TECHNICAL BULLETIN :

T0005

G2492 MK III Top Turn Glider Arm Design

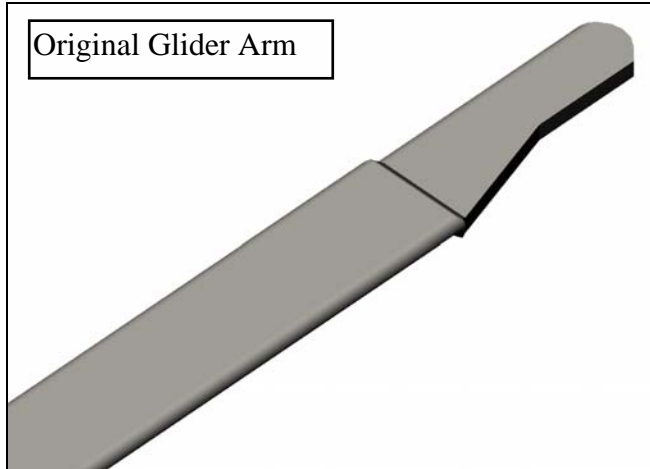
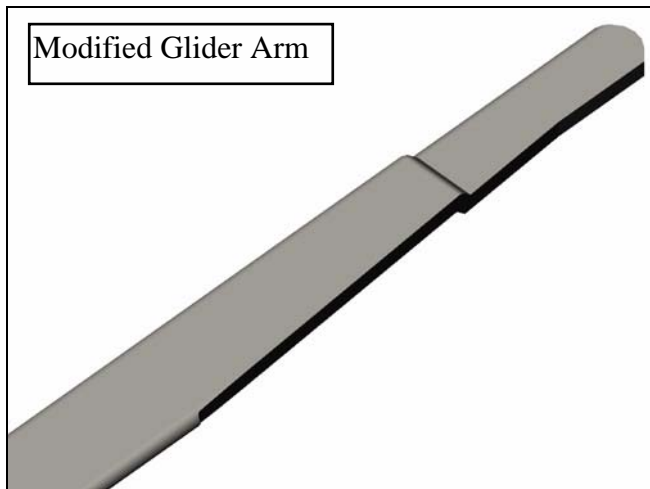
As part of our continuous improvement programme in product development, Grorud have modified the shape and size of the G2492 top turn glider arm.

**This modification will result in a different centre sash casting position.
Please refer to the new Installation and Maintenance Instructions.**

1. The cut-out section has been modified to aid clearance between the arm and the bracket when in the wash position.

2. The overall length of the arm has been increased by
i) 4mm in the M8 to M10.5 range
ii) 6mm in the M11 to M13 range
iii) no change in the M13.5 to M18 range
